File No. 111247 Committee Item No. 2
Board Item No. _____

[Planning Code - Permitting a Five Feet Ground Floor Height Increase in the 40-X and 50-X Height and Bulk Districts in the NC-3 Zoning District Along Geary Boulevard]

Re: **Transmittal of Planning Case Number 2011.1382T**
BF No. 11-1247- Five Foot Height Increase for Active Ground Floor Uses
In Contiguous Commercial Corridors in the Richmond District

Executive Summary
Planning Code Text Change
HEARING DATE: FEBRUARY 2ND, 2012

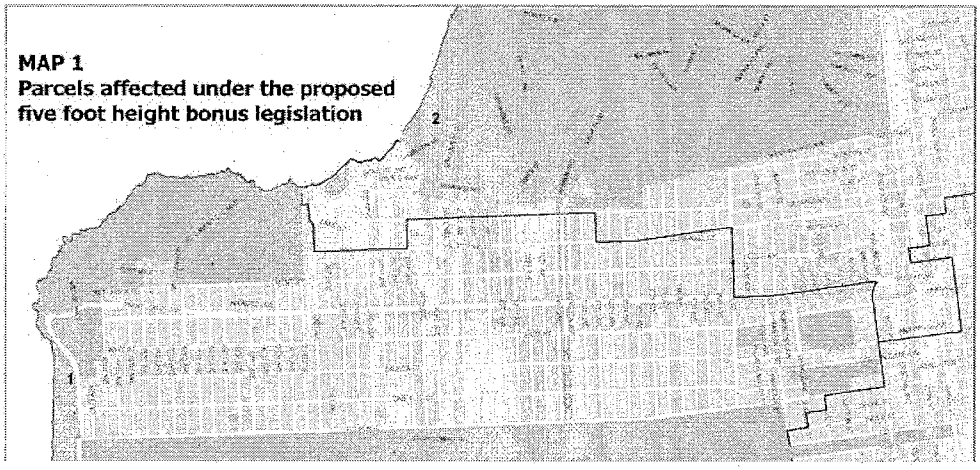
This map illustrates the proposed height bonus as proposed by Supervisor Mar. This proposal focuses on sections of Geary Boulevard which currently fall within either a 40 or 50' height district. There are some discontinuous stretches where higher height limits (more than 50-x) would allow a generous groundfloor space within the existing height limits and thus do not need the proposed bonus to create successful groundfloor spaces.

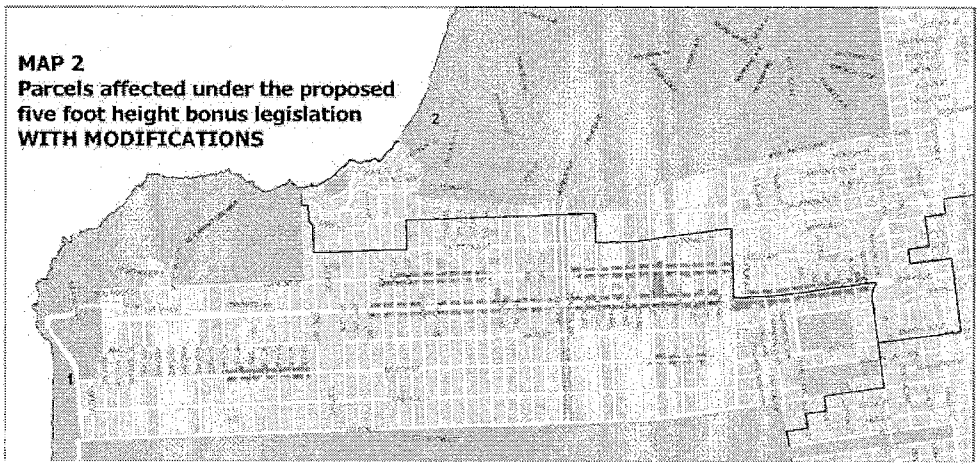
The Department recommends modifying the Supervisor's proposal along Geary Boulevard to limit eligible parcels to those that are west of Masonic Avenue. There were only a few parcels east of Masonic Avenue that were eligible under the Supervisor's original proposal. However, since Masonic Avenue sits at the crest of Geary, it serves as a visual gateway to the Richmond neighborhood and is therefore a logical marker to begin this opportunity.

This map illustrates the proposed Ordinance with modifications recommended by the Planning Department. This proposal creates contiguous linear stretches where the bonus would be offered. The height bonus would begin at the crest of the hill on Geary at Masonic. This eastern gateway marks the visual entry to the district. In addition, the Department recommends applying this to other contiguous commercial stretches in the Richmond District.

- **Accept the Supervisor's proposed Ordinance with modifications to apply the proposed Ordinance to contiguous commercial corridors in the area, beginning at the crest of Geary Boulevard at Masonic Avenue and including portions of both Balboa and Clement Streets.**

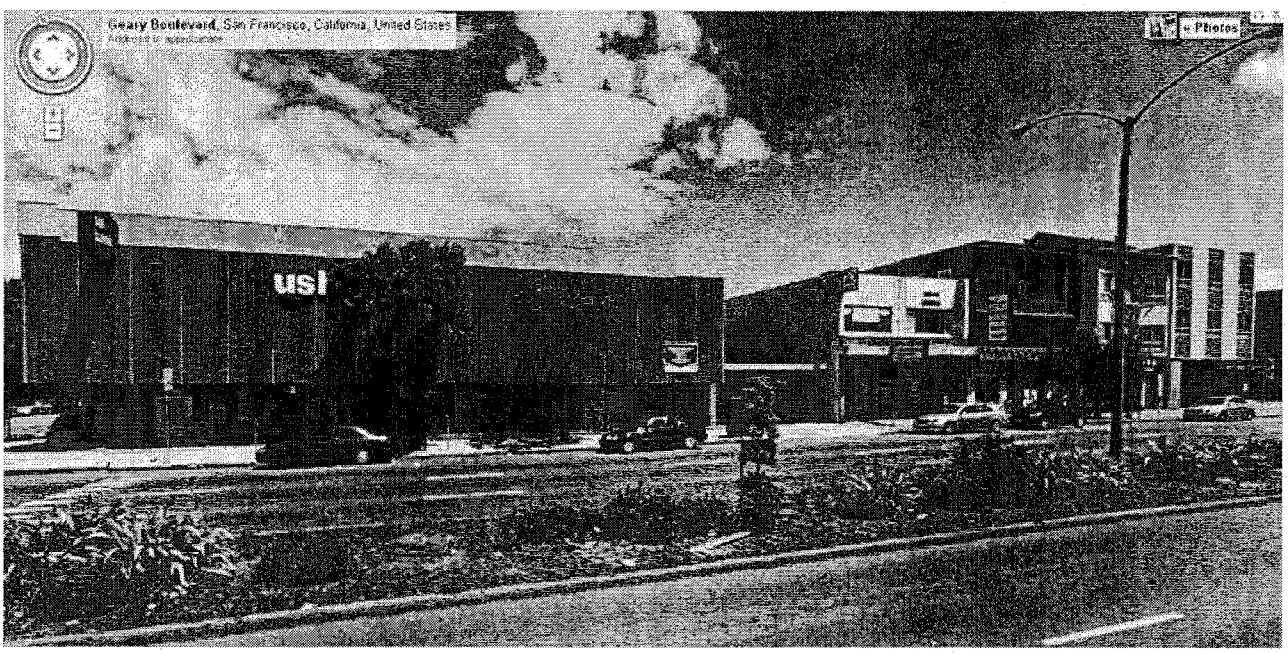
Now look at the existing buildings from Palm to Jordan, Jordan to Commonwealth and Commonwealth to Parker in our Jordan Park Improvement Association area. Note that the buildings are basically only 4 stories tall.

Palm to Jordan, northside of Geary...all 40-X. Behind these lots are the RH-1/RH-2 lots of Jordan Park.
This and below images courtesy of Google.

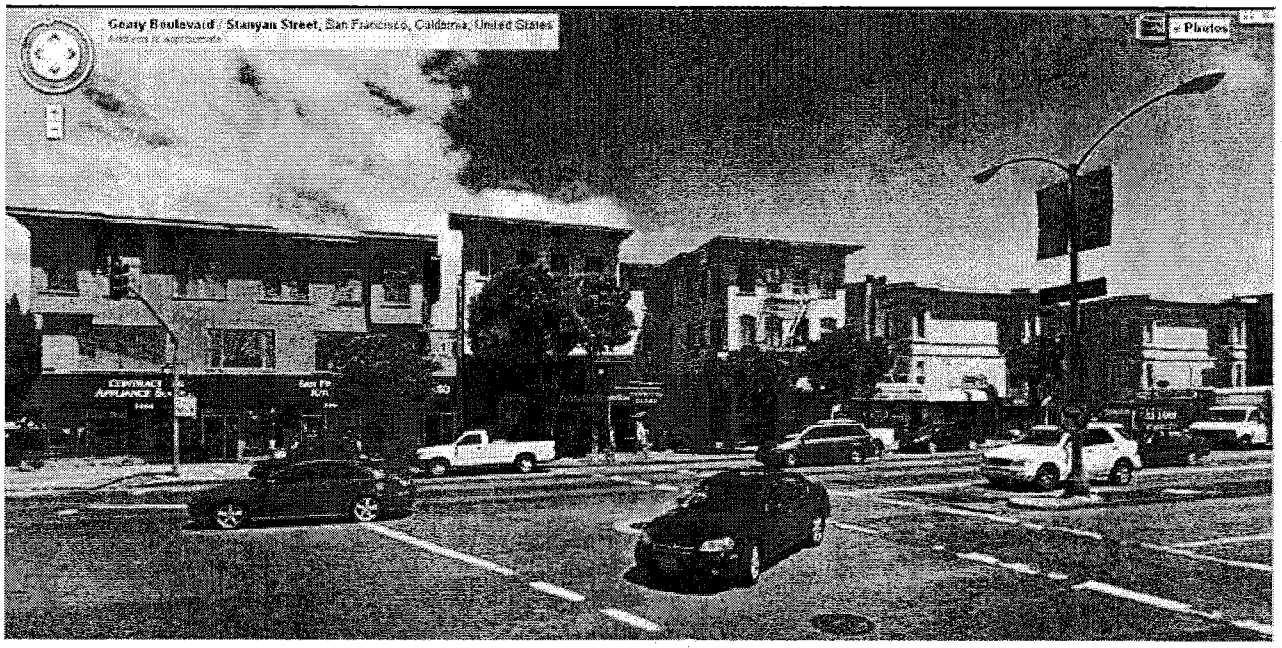
Jordan to Commonwealth, northside of Geary...all 40-X. Behind these lots are the RH-1/RH-2 lots of Jordan Park.

Commonwealth to Parker, northside of Geary...all 40-X. Behind these lots are the RH-1/RH-2 lots of Jordan Park.

Question:
Why is it that the 5' height increase is being done as if all blocks along Geary are the same? The blocks between Palm Ave and Parker Avenue are different than the entire length of Geary due to RH-1 and RH-2 lots that ABUT RH-1's which in turn ABUT the Geary lots. The same between Wood St. and Blake St. with this similar situation. These areas are truly old historical areas of a different character and are unlike the rest of Geary such as near the Kaiser Hospital near Divisadero or farther west towards 18th Avenue where WHOLE city blocks are COMPLETELY RH-2s and higher near Geary. The blocks of Palm, Jordan, Commonwealth, Parker in Jordan Park Neighborhood Association need to be made an exception with this very different low-density lot set up similar to RH-1s and RH-2s that abut around 9th and 10th Avenues between Balboa and Anza or like Seacliff which has RH-1s/abutting RH-2s.
Please make this change in the proposed ordinance. Jordan Park homes do not reflect the same characteristics nor the fully higher zoning of an ENTIRE city block of RH2s like the rest of the blocks on Geary. This may not be "unique" but it certainly tells you about the very special

nature of these blocks and is extraordinary and unusual for this length of Geary.
I strongly suggest that Geary between Palm and Parker inclusive be excluded in the ordinance.
Please forward to planner who is in charge of this if you are not. Thank you very much.
Sincerely,
Rose Hillson
Member, Jordan Park Improvement Association
